Office Action Summary	Application No. 10/585,047	Applicant(s) LUTZ ET AL.	
	Examiner JOHN K. KIM	Art Unit 4125

DETAILED ACTION

sketch from Fig. 2

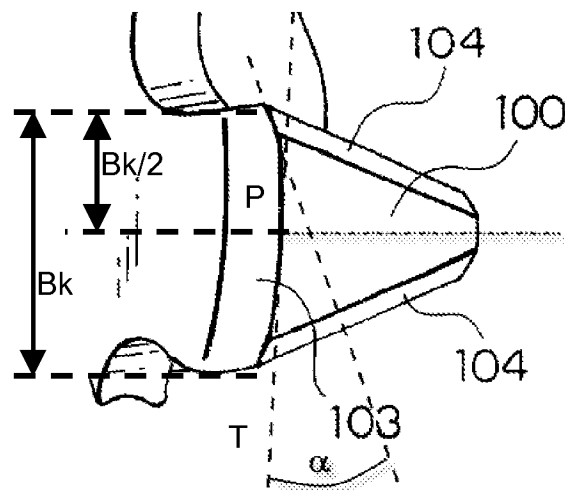
that is vertical to the pivot axis (axis of 6), defines a point (P), and a tangent (T) can be inscribed into this point (P), (see sketch below)

and an angle of inclination α which has a magnitude of between 15° and 25° is enclosed between the tangent (T) and the chamfer (101) in the plane that is vertical to the said pivot axis. (see sketch below)

sketch from Fig. 7 (alpha is 22 degrees)

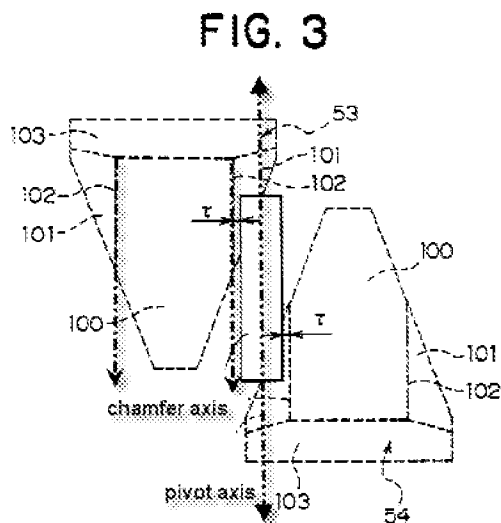
As for claim 3, Asao teaches the claimed invention as applied to claim 1 above. Asao further teaches (in Fig. 2) the chamfer (101) has a center (m) in the edge direction (see sketch above) that is located close to the transition plane (103 and 100 border plane) from the pole root (103) to the freely projecting part of the claw pole (100).

Asao further teaches (in Figs. 1-3) the chamfer (101) is a plane which is oriented parallel to the pivot axis direction (axis of 6). (see sketch below)

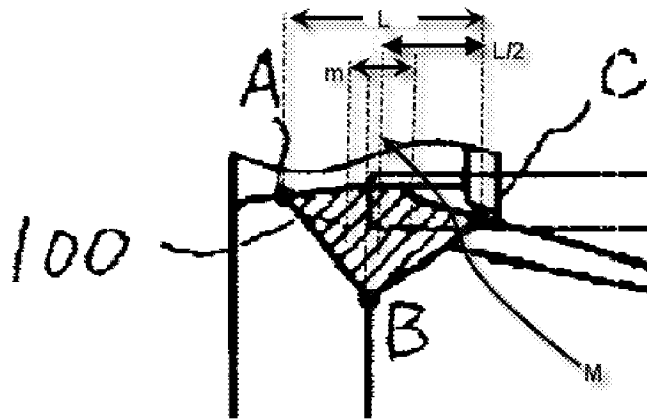
As for claim 2, Asao teaches the claimed invention as applied to claim 1 above. Asao, however, failed to teach the center portion m amounts to 1/3 of the length (l) of the chamfer (68). In the same field of endeavor, Oohashi teaches (in Figs. 3, 7, 9 and sketch below) the center portion m amounts to 1/3 of the length of the chamfer (100). Therefore, it would have been obvious to a person of ordinary skill in the art at the time the invention was made to make the center portion m amounts to 1/3 of the length of the chamfer by combining the teaching of Oohashi with that of Asao for reduction of high band noise.
